### Staff Report to the Technical Review Committee December 2, 2014

Applicant Frank Usina, Project Man- ager, City of Orlando	<b>Property Location:</b> Northeast corner of W. Church St. and Glenn Ln (± 10.5 acres, District 5).
<b>Owner</b> City of Orlando	<b>Applicant's Request:</b> Replat property for development of the Or- lando Soccer stadium.
<b>Project Planner</b> Karl Wielecki, AICP	<b>Staff's Recommendation:</b> Approval of the request, subject to the conditions in this report.
Updated: December 1, 2014

# PROPOSED PLAT

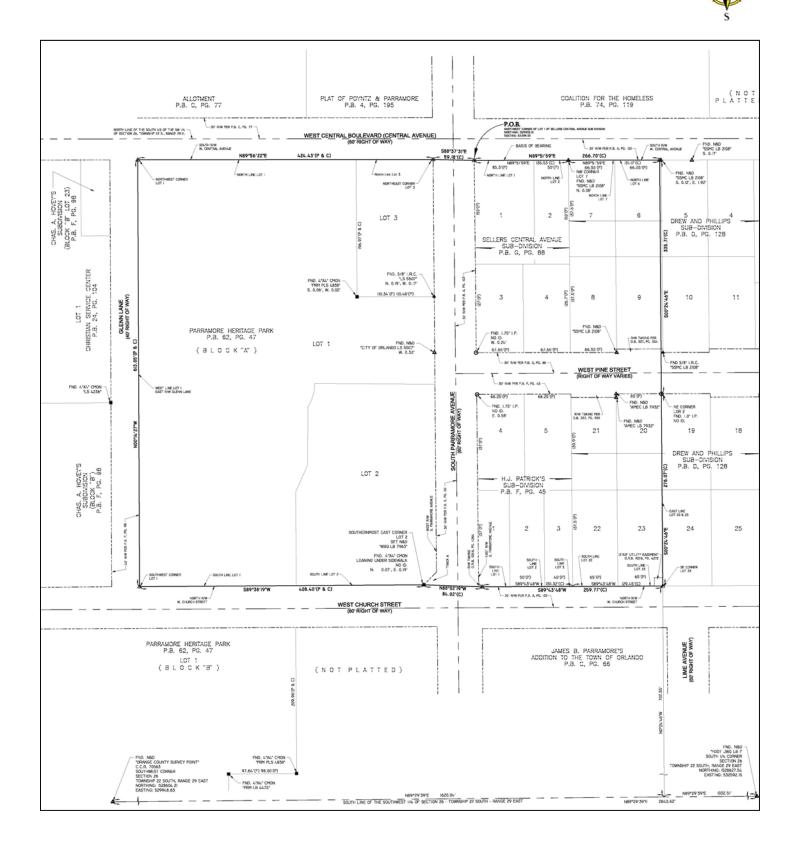
- 1. Except as provided herein, the proposed plat is subject to all codes and ordinances of the State of Florida, City of Orlando, and all other applicable state regulatory agencies. Any applicable state or federal permits must be obtained before commencing development.
- 2. Development shall be consistent with conditions of the associated Planned Development and Abandonment applications ZON2014-00028 and ABN2014-00003.
- 3. This plat approval is subject to the City Council adoption of the ordinance partially abandoning Parramore Ave. and Pine St., as described in the staff report for case ABN2014-00003.

- 2. As per Section 61.225 of the Land Development Code and the Downtown Development Board, a 13 foot wide concrete sidewalk is required along all dedicated rights-of-way, unless other site specific specifications are given. Any existing sidewalk damaged or broken is to be repaired.

- 3. The final recorded plat shall contain the following note:"Development on the property depicted on this plat is subject to the requirements of Chapter 59, the Concurrency Management Ordinance of the City of Orlando, which governs the City's ability to issue building permits on this property. Approval of this application shall not be deemed to provide any vested rights, except as to those matters depicted hereon, that are consistent with the requirements of Chapter 177, Florida Statutes, or were required by the City of Orlando as a condition of platting."
